**SUBJECT: LASALLE COUNTY STATION, UNITS 1 AND 2—SPECIAL INSPECTION
TEAM REPORT AND EXERCISE OF DISCRETION; INSPECTION
REPORT 05000373/2017009; 05000374/2017009**

Report No: 05000373/2017009; 05000374/2017009

Facility: LaSalle County Station

Figure 2 - Threaded Connection Diagram Initial Condition

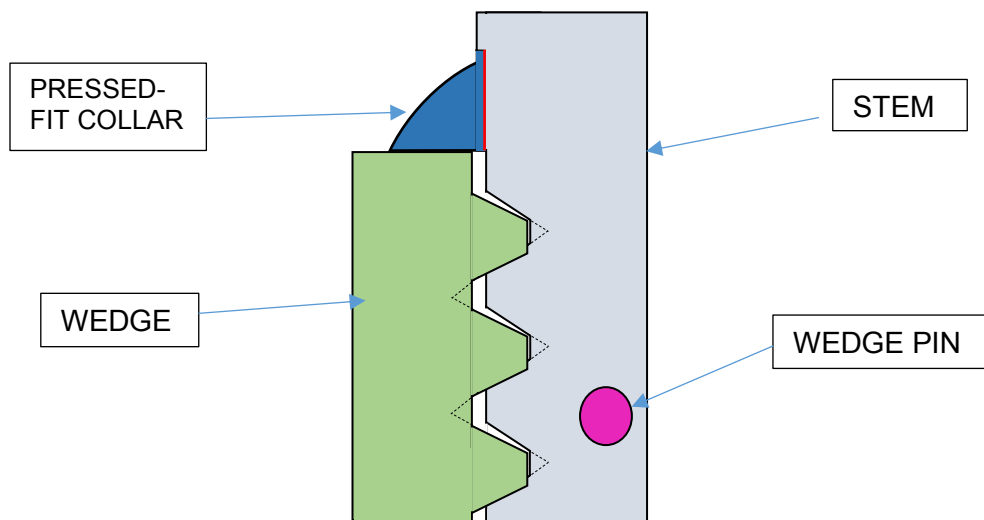
- **Initial Conditions.** The stem was manually threaded into the wedge with an initial preload that loaded the collar and put the stem threads into tension. The stem-to-wedge threaded connection was then pinned by drilling a hole through the wedge-stem-wedge. The initial installation torque and preload applied was very low and estimated to be less than 38,000 lbf based upon the pressed-fit collar capacity.

Figure 3 - Threaded Connection Degradation Diagram

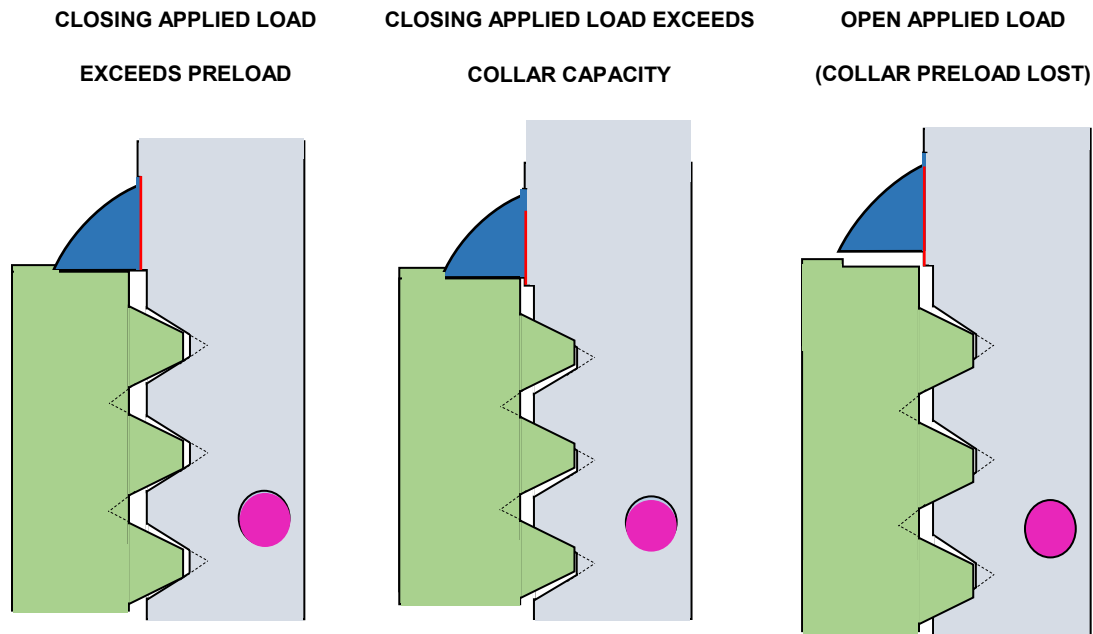
- **Collar Slip/Loss of Preload.** The normally applied closed thrust loads of over 200,000 lbf exceeded the pressed-fit collar load capacity, causing it to slip. Once the collar slipped, preload was lost.
